**ADDENDUM NO. 2**

**CITY OF HIALEAH  
DEPARTMENT OF PUBLIC WORKS  
3700 W 4 AVE  
HIALEAH, FLORIDA**

The original Contract Documents, for the Project entitled **CITY OF HIALEAH – PUBLIC WORKS COMPLEX-PICKET FENCE AND GATES-BID# 2014/15-9500-00-035** is hereby amended as noted in this **Addendum No. 2.**

Key Switch Sample-Picture

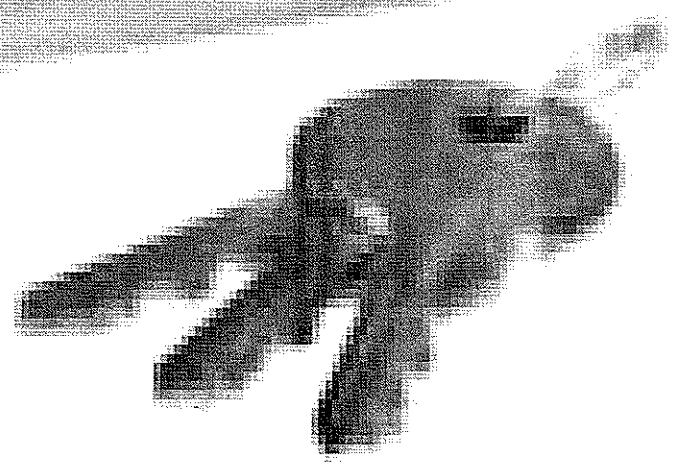
1. The fence contractor must provide emergency key switch at all electric/motorized gates as required by the fire department (refer to attached sketch for locations).
